Access Compliance Report

Public Rights-of-Way

Intersection ID: 27556	Main Street: LEDERER_AV	Cross Street: QUEARY_CT	Location: NE
ADA ID: F8E0553B2156	Ramp Type: Perp	Initial Pass/Fail: Fail	Overall Compliance: No
		Severity Score: 12.5

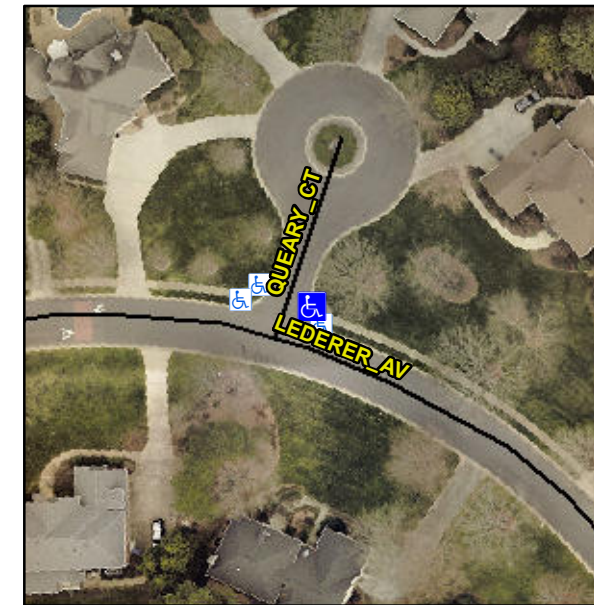
Not Found, R304.5.3

Compliance	Description	Data	Compliance	Description	Data
N/A	Ramp Length (in)	79.0	Yes	Ramp Slope (%)	8.0
Yes	Ramp Width (in)	48.0	No	Ramp XSlope (%)	5.6
N/A	Flare Type LT	N/A	N/A	Flare Type RT	N/A
N/A	Flare Slope LT (%)	N/A	N/A	Flare Slope RT (%)	N/A
N/A	Flare Traversable LT?	N/A	N/A	Flare Traversable RT?	N/A
N/A	Landing Length (in)	N/A	N/A	DWS Provided?	N/A
N/A	Landing Width (in)	N/A	N/A	DWS Contrast?	N/A
N/A	Landing Slope (%)	N/A	N/A	DWS Length (in)	N/A
N/A	Landing X Slope (%)	N/A	N/A	DWS Full Width?	N/A
N/A	Landing Curb? (Y/N)	N/A	N/A	DWS Offset (in)	N/A
N/A	Shared Landing?	N/A			
N/A	Gutter Ponding?	N/A	N/A	Gutter Slope (%)	N/A
N/A	Gutter Lip Ht (in)	N/A	N/A	Gutter X Slope (%)	N/A
N/A	Painted X Walk1?	No	N/A	Painted X Walk2?	N/A
	X Walk 1 Direction	To NW		X Walk 2 Direction	N/A
N/A	X Walk 1 Width (in)	N/A	N/A	X Walk 2 Width (in)	N/A
	X Walk 1 Slope (%)	4.5		X Walk 2 Slope (%)	N/A
	X Walk 1 X Slope (%)	5.0		X Walk 2 X Slope (%)	N/A

Remove & Replace Entire Ramp.
